# Wisconsin Department of Transportation

**Proposal #31: 1601-13-60**  
**Eagle River - Land O Lakes**  
**Culvert Replacement C-63-13**  
**USH 45**  
**Vilas County**

This is Addendum No. 01, which provides for the following:

**Addendum No. 01  
ID 1601-13-60  
Revised Sheet 4  
May 4, 2017**

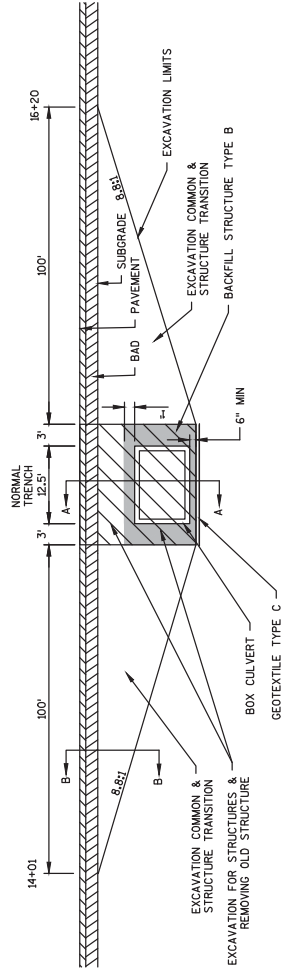
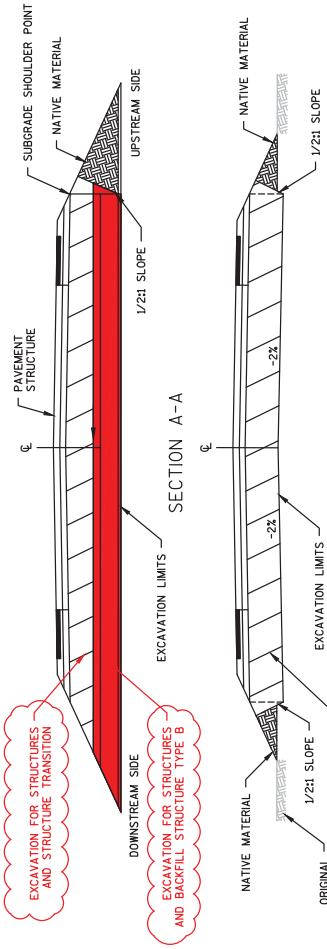
Revised Plan Sheets	
Plan Sheet	Plan Sheet Title (brief description of changes to sheet)
4	Replace NOTE within the "Box Culvert Excavation and Installation Detail" to clarify backfill requirements. Modify Section A-A within the "Box Culvert Excavation and Installation Detail" to clarify excavation and backfill limits.
42	Replace backfill pay limit NOTE in LEGEND to clarify backfill requirements.

NOTE: UNLESS DETERMINED TO BE UNUSABLE BY THE ENGINEER, ALL MATERIAL REMOVED IN THE TRANSITION CUT AND STRUCTURE EXCAVATIONS TO BE REUSED AS BACKFILL IN ALL AREAS EXCAVATED FOR THE BOX CULVERT AND TRANSITION AREA EXCEPT WHERE BACKFILL STRUCTURE TYPE B IS SHOWN.
